October 2022 Zoning Committee Report

North Linden Area commission

CV22-080 at 1371 Aberdeen Ave (new duplex)

BZA22-119 at 2977 Cleveland Ave (Kenlawn sign)

Figure 1: The front elevation of the proposed house at 1371 Aberdeen Ave. Image included in application packet.

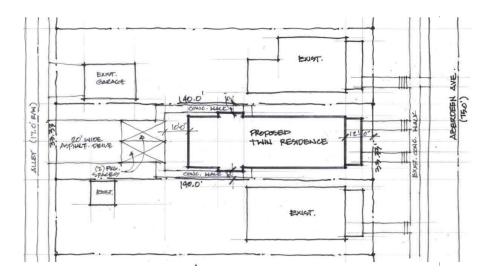
- Parking spaces, Section 3312.27: 2-off-street parking spaces are required per dwelling; the application says that only 3 are possible. The drawings appear to show space for 4 cars in a double-stacked arrangement; this variance for a parking reduction doesn't seem like it reflects the actual number of cars that can park on the lot.

- Parking Pad, Section 3332.28: The parking pad can't be in the minimum required side yard. The lot requires 6.6 feet of side yard, 20% of lot width. The applicant says that in order to accommodate 3 parking spaces, one parking space will encroach on the west sideyard by 4 inches, while still leaving at least 3 feet of sideyard. Aerial imagery maintained by the Franklin County showed a solid wooden fence on the west side of the property, separating the proposed parking pad at 1371 Aberdeen from the yard and garage of 1363 Aberdeen.

Zoning committee recommendation: Approve this variance application. It will provide necessary housing in our community.

Figure 3: Dimensions of the sign. Image included in application packet.

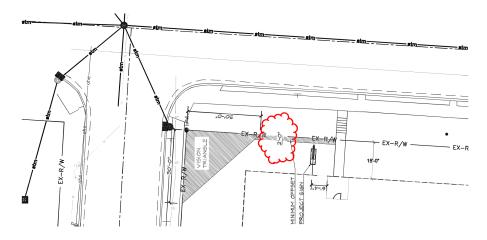
Kenlawn Place wants to put a sign less than 15' from the road, a ground sign about 5' tall and 7' wide, composed of a 3' by 5'6" sign on a brick base, on top of the little grass hill they have in front of the apartment building. Sign would be at the intersection of Eddystone and Cleveland Avenues.

• 3376.04-A "A ground sign shall be set back no less than 15 feet from any abutting street right-of-way line, except where the established building line applicable to the subject site is less than 15 feet from the right-of-way line of the street to which the sign is directed. Where the established building line is less than 15 feet, a ground sign may be installed at a reduced setback, subject to height and graphic area limitations. The required sign setback line shall be no less than two feet from the right-of-way line of the street to which the sign is directed and no less than two feet from any public sidewalk or shared-use path." The sign will be set back about five feet from the nearest sidewalk, based on renderings provided by the applicant, and included below. The vision triangle for turns to and from Eddystone Avenue is kept clear.

Zoning committee recommendation: Approve this variance. The sign is unobtrusive.
